CASE NO.: C8-2022-0169

SUBDIVISION NAME: Evelyn Tract Preliminary Plan

**CITY OF AUSTIN –DEVELOPMENT SERVICES DEPARTMENT
SUBDIVISION APPLICATION – MASTER COMMENT REPORT**

CASE NUMBER: C8-2022-0169
UPDATE: U1
CASE MANAGER: Cesar Zavala Email: cesar.zavala@austintexas.gov

GENERAL NOTES

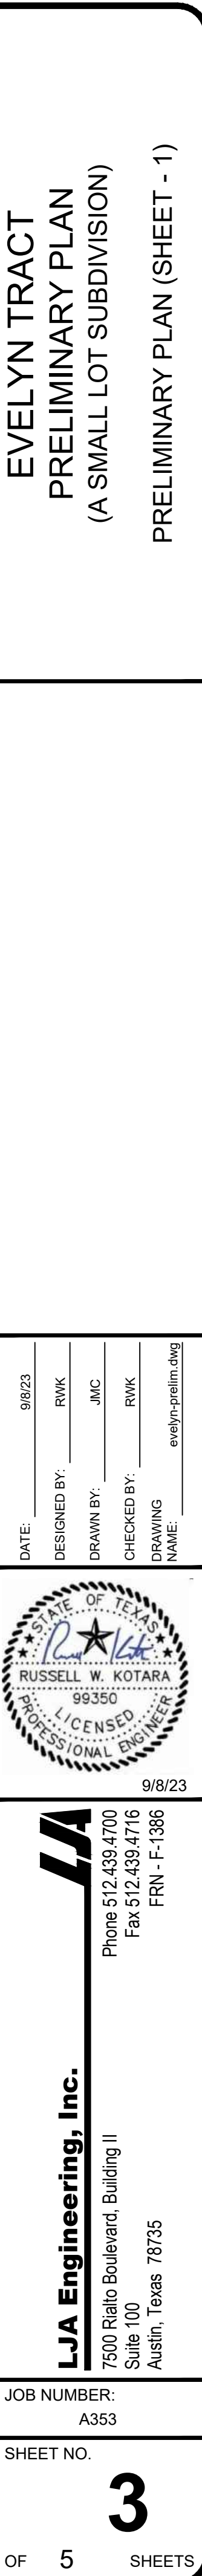
SR 3. Verify that Note #30 list all the lots accordingly, it appears lots are left off the note, such as Lot 3 Block P, and Lot 25 Block M. LDC 25-1-83

Update 1: In Note #30 delete the last listed Lot 1, Block F, this is a duplicate.

EVELYN TRACT
PRELIMINARY PLAN
(A SMALL LOT SUBDIVISION)
ADJACENT OWNERS MAP

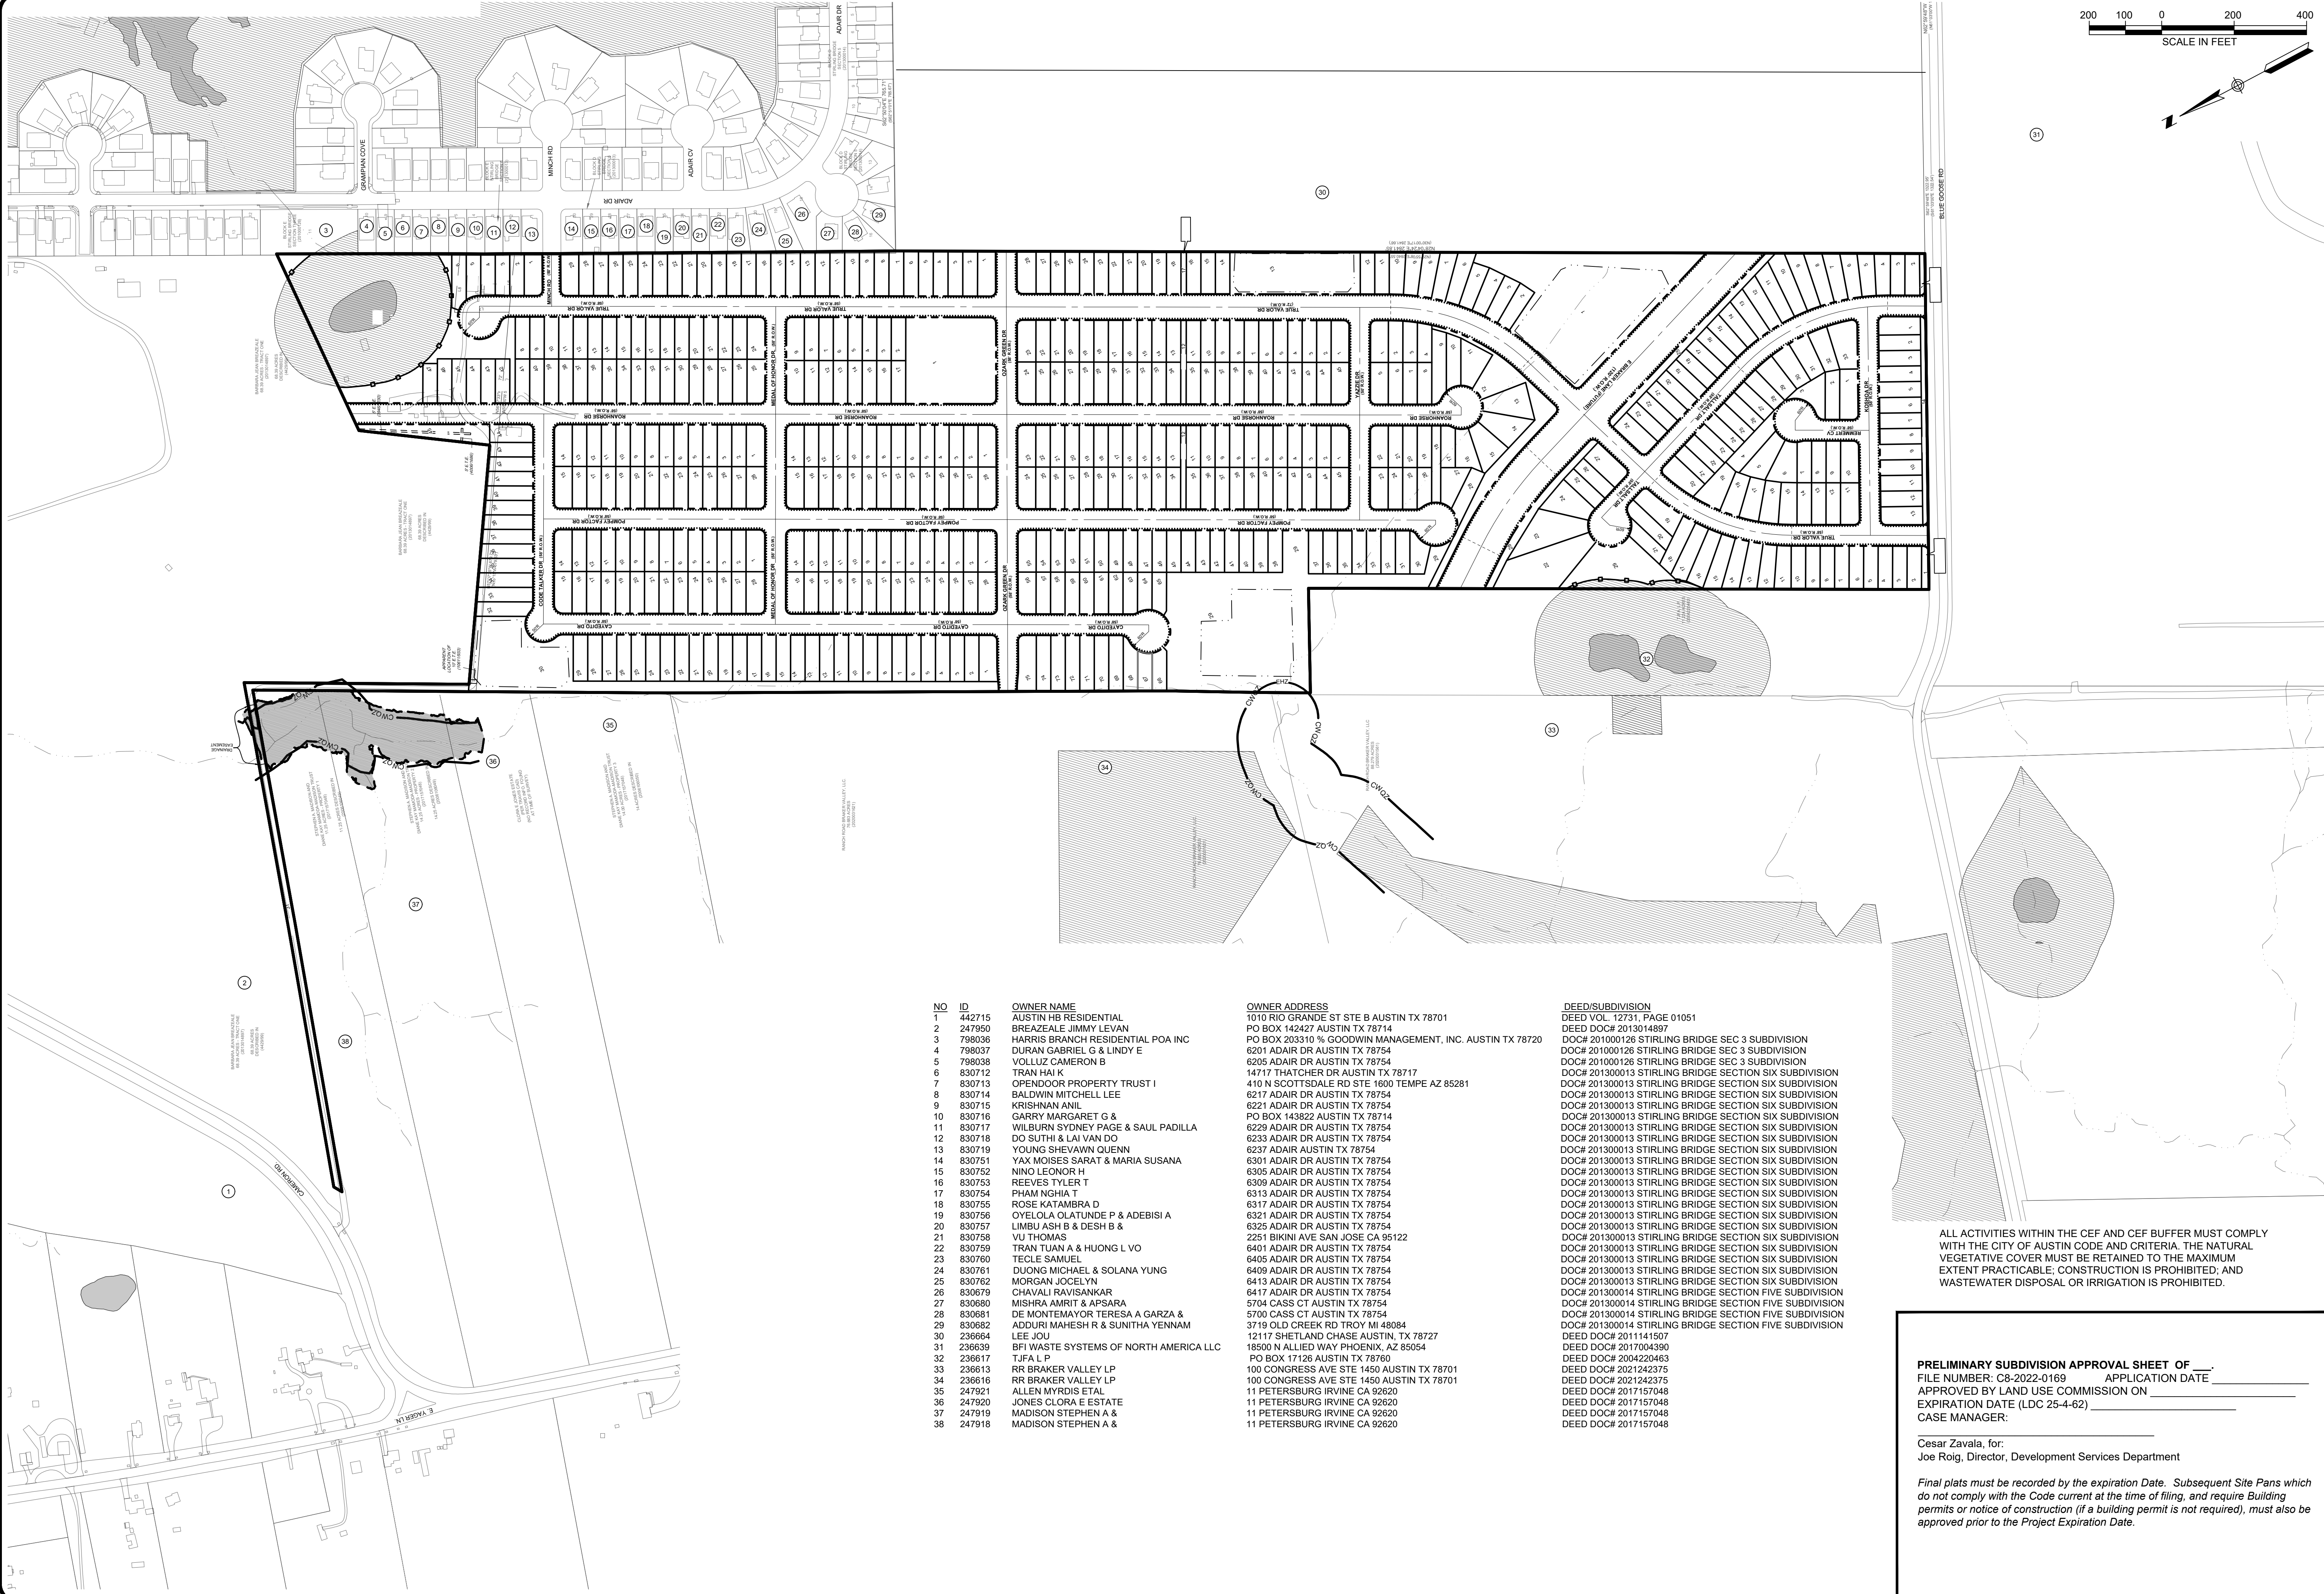
- AD1: This preliminary review is Rejected for the following reasons:
- AD2: In the location map and sheet 5 of 5 please remove the punctuation marks in E YAGER LN
- AD3: Please remove the punctuation mark from CAMERON RD on all sheets, sheet 4 of 5 and from sheet 5 of 5.
- AD4: Please remove all forms of punctuation after abbreviating street types or directionals on all sheets including the location map.
- AD5: The continuation of Ozark Glen Dr has been approved for use; however, the street label for Ozark Glen Dr is not labeled correctly on your plans. Please relabel Ozark Green Dr to Ozark Glen Dr on all sheets and resubmit.
